**STATE OF CALIFORNIA
STATE WATER RESOURCES CONTROL BOARD**

Cleanup and Abatement Order No. R9-2025-0014

PETITION FOR REVIEW

Figure 1: Location of Properties

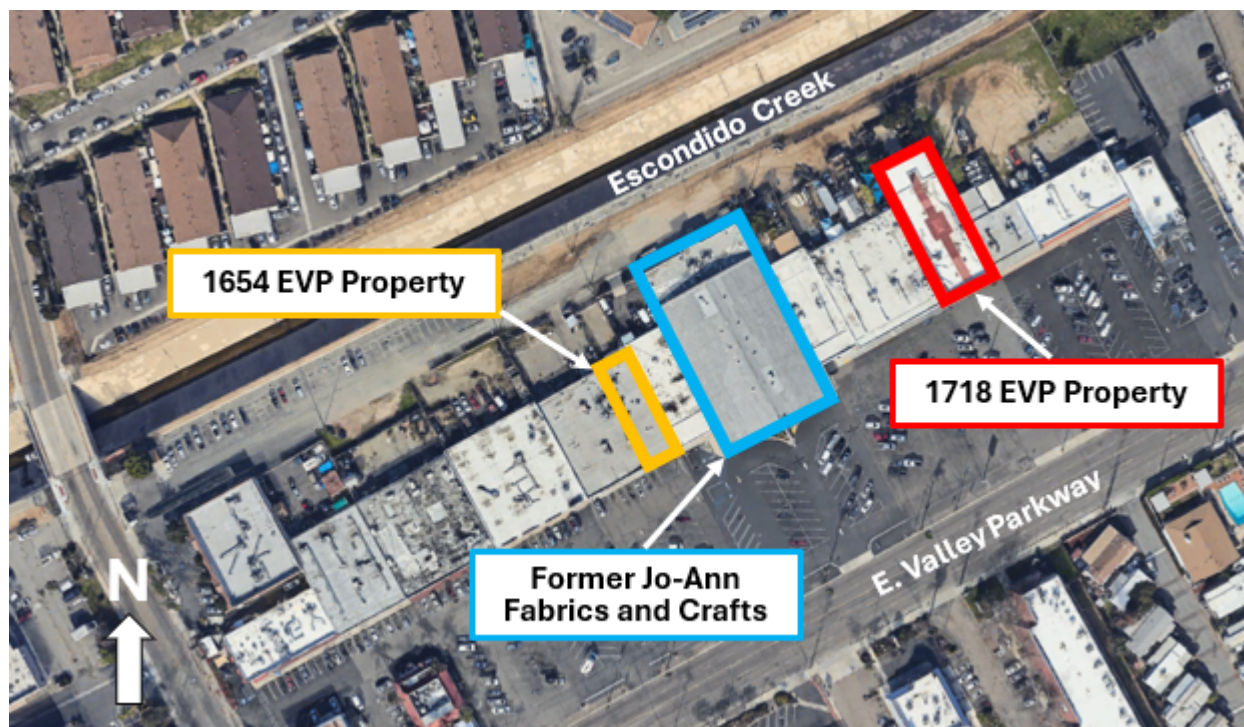
2j	Figure 1	Figure 1 of the TCAO improperly identifies the boundary of 1654 EVP to include 1652 EVP, the suite located adjacent to the west-southwest of 1654 EVP. This illustrates a lack of San Diego Water Board staff's understanding of site conditions.	San Diego Water Board staff disagree with the comment. The purpose of Figure 1 is to illustrate the approximate locations of 1654 EVP and 1718 EVP relative to the former Jo-Ann Fabrics and Crafts (1680 EVP). The boundaries are shown more accurately on Figures 2 to 4, which show the results of the passive soil vapor survey. These boundaries were drawn based on Figure 1 of IES's November 2, 2022, passive soil vapor technical memorandum. San Diego Water Board staff have, however, revised the TCAO in response to this comment to refine the property boundary of 1654 EVP. See Figure 1.
2k	Finding D	Now there is data available that indicates a release has not occurred at 1654 EVP, but the TCAO ignores these facts. This illustrates a lack of San Diego Water Board staff's understanding of site conditions or inherent bias against my client.	San Diego Water Board staff disagree with the comment. IES recommended that the San Diego Water Board provide a "no further action" determination for 1654 EVP based on the results from the (1) February and March 2022 site investigation to evaluate soil, soil vapor, and groundwater conditions at the Site, and (2) September

Comment No.	TCAO Section	Comment Summary	San Diego Water Board Staff Response
			<p>2022 passive soil vapor survey to evaluate the source(s) and lateral extent of chlorinated solvents in soil vapor beneath the Site. San Diego Water Board staff disagreed with this recommendation.</p> <p>San Diego Water Board staff have, however, revised the TCAO in response to this comment to provide clarity regarding this finding. See Findings D.3.viii and D.3.x.</p>
2l	Finding D	There is no indication in the TCAO that the administrative file regarding 1654 EVP was clean, illustrating the inherent bias that my client is being subjected to by San Diego Water Board staff.	<p>San Diego Water Board staff disagree with the comment.</p> <p>On February 7, 2020, DEH issued an official notice to Guhn Kim recommending that he enroll in the Voluntary Assistance Program due to a potential release of PCE from the Suzy Cleaners facility. DEH's recommendation was based on review of the environmental reports described in Findings D.3.i to D.3.vii of the TCAO. On May 5, 2020, DEH issued another official notice to Guhn Kim providing responses to Procopio's April 22, 2020, comment letter regarding the Suzy Cleaners facility. Procopio's letter suggested that a source of the PCE may also be the former Ha's Cleaners located at 1718 EVP. DEH concurred with Procopio; however, DEH still maintained its February 7, 2020, position regarding the Suzy Cleaners facility.</p> <p>San Diego Water Board staff have, however, revised the TCAO in response to this comment to provide clarity regarding these findings. See Finding D.2.</p>

Figure 2: Passive Soil Vapor Analytical Results for cis-1,2-Dichloroethene

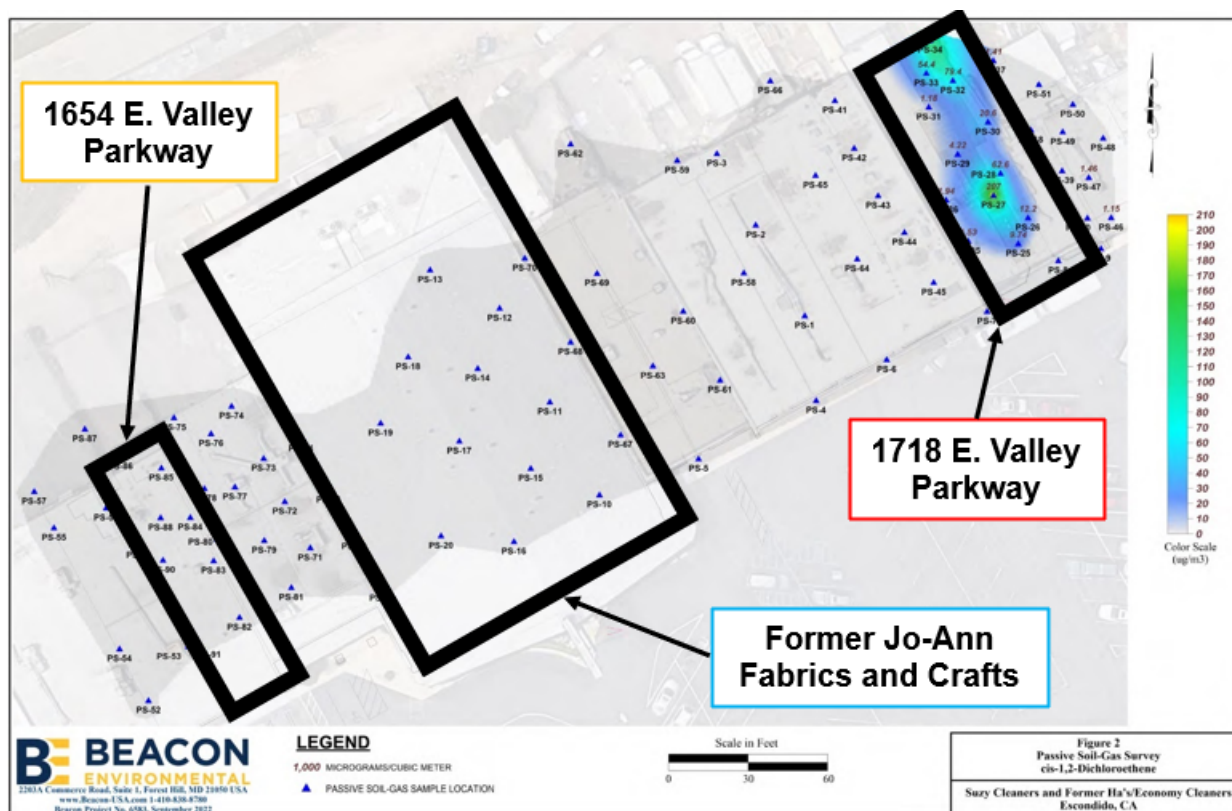
The results of this investigation indicate the existence of two separate releases of PCE, both from 1718 EVP. The presence of two distinctive oval shaped DCE patterns in close proximity to one another at the 1718 EVP location (Figure 2), illustrate where reductive dechlorination of PCE to TCE then DCE is actively occurring. As discussed, DCE very high mobility classification indicates that it does not linger in the environment and therefore the presence of DCE

In addition to the existence two DCE plumes in close proximity at 1718 EVP shown on Figure 2, Figures 3 and 4 illustrate the current locations and migratory path of the down (groundwater) gradient PCE plumes, the southern release having migrated approximately 350 feet to the PS-54 location, and the northern release having migrated approximately 100 feet to the PS-2/PS-58 location. The relative dispositions of the two down-gradient plumes in juxtaposition with the source area DCE footprint indicate that two separate releases took place at different times, and migrated with groundwater along similar trajectories and at similar rates to the west-southwest. Assuming consistent groundwater flow throughout the study area, the southern release from 1718 EVP would then pre-date the northern release. The migrating dissolved or DNAPL plumes would continue to emit TCE and PCE gas as they migrate with groundwater, which in turn would impact soil gas in proximal locations.

AO, D.3.x, improperly and inappropriately by omission summarizes the results of this investigation then states clearly that the “San Diego Water Board staff disagreed with [the Petitioner’s consultant] IES’s recommendations of a No Further Action Determination.” The SD Water Board’s decision to inappropriately by omission summarize the results of this investigation while highlighting their disagreement creates an inherent bias against the Petitioner, and inappropriate and improper. The AO does, however, utilize the figures from this phase of assessment, which clearly show the west-southwestern migration of PCE and TCE, as well as the two source locations, identified from the DCE chemical fingerprints at 1718 EVP.
